## Visa International Mini Jets ride – modification to lower levelling bars

**Regarding failure on Mini Jet Ride**

*Instant modification on lower leveling bar of mini jet rides.*

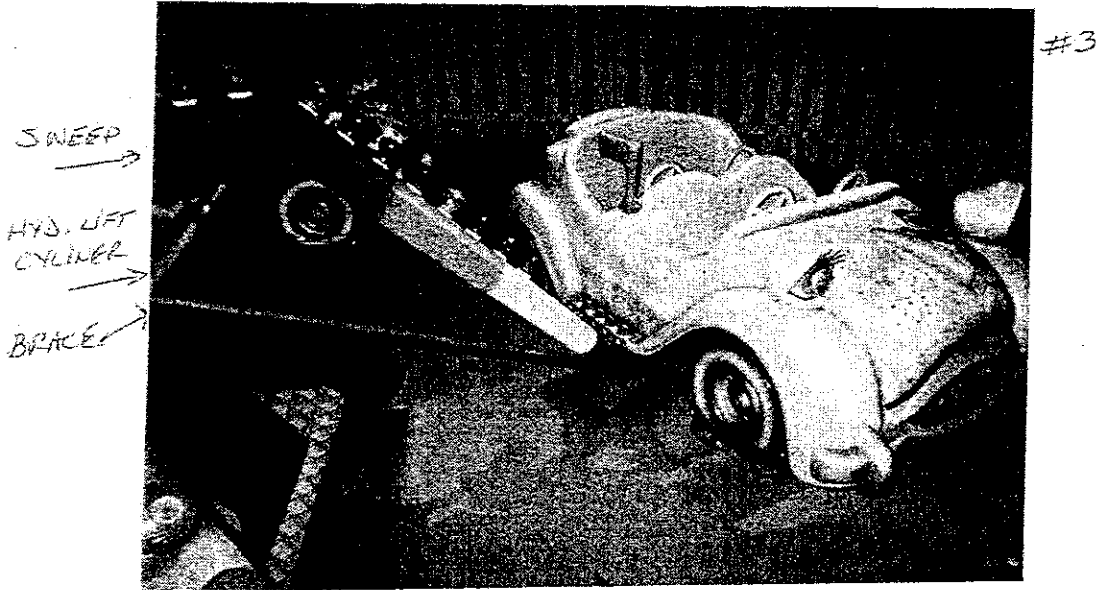
Dear Mike Reinhart, after reviewing you fax from Nov. 18.2002, an instant modification on the mini jet rides has to be to add 2 grease fittings on each of the upper support of the leveling bar (center hub connection). For this the leveling bars have to be dismantled two holes have to be drilled on each sweep (left and right side of tubing) and two grease fittings have to be added per support.

Before installation of leveling bars, the bars have to be visually inspected for any deformation and the top pin (center hub side of the bar) has to be sanded, cleaned and greased.

These grease points have to be greased every 40 operational hours.

We feel that after this instant modification a seizing of the upper joint of those bars can be eliminated, and the ride can be operated safely.

#1. This photo taken by Inspection Specialist Guay on 11/12/02 shows the ride configuration for one tub. The tube marked "Brace" goes from the center hub of the ride to underneath the tub. The "Brace" keeps the tub level as it is hydraulically lifted up approximately two feet.

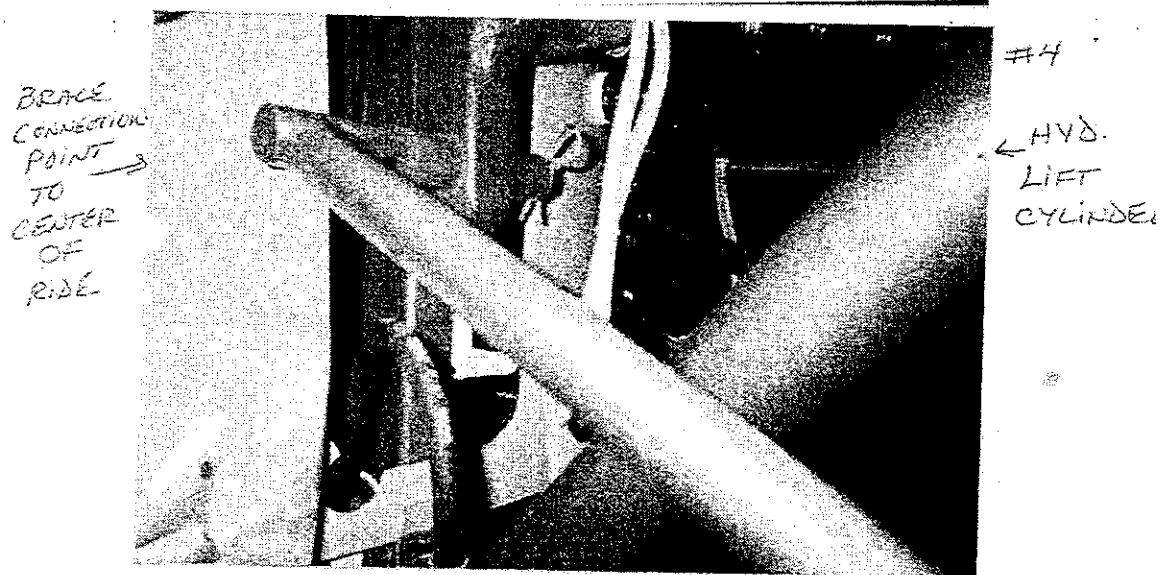
#2. This picture, also take by Inspection Specialist Guay on 11/12/02 shows where the "brace" attaches to the center of the ride above the hydraulic lift cylinder. There is no grease fitting on the brace or its' attachment point.

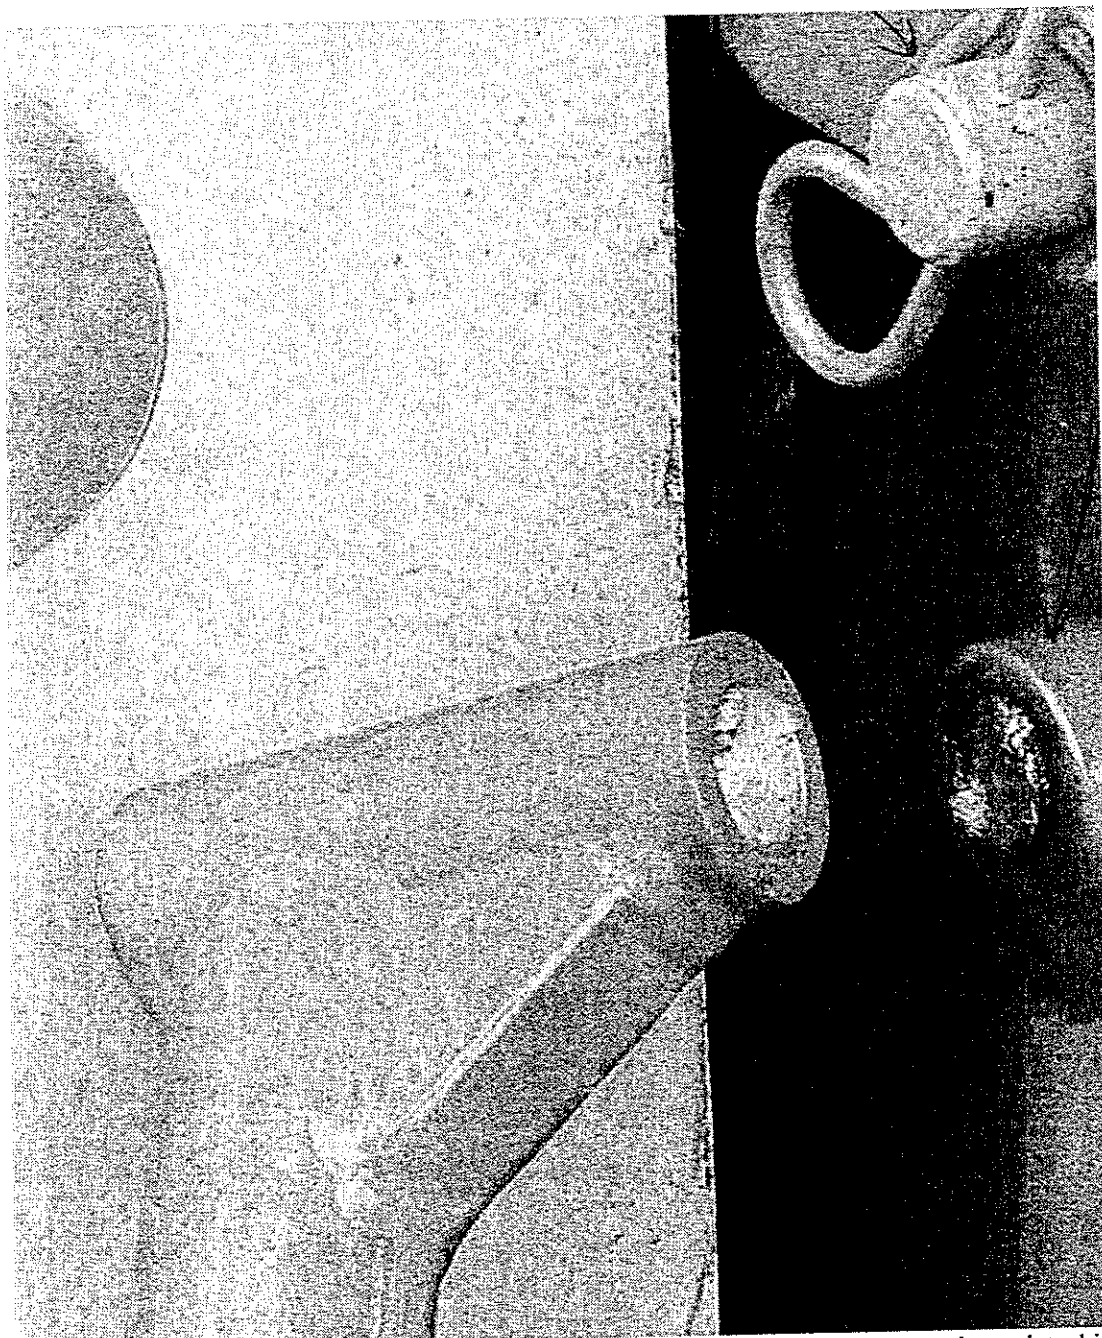
#3. Digital photograph taken by "Sam's Fun City" employee showing the brace connection point which failed. Notice the pin is fused inside the sleeve on the right where it broke off of the brace.
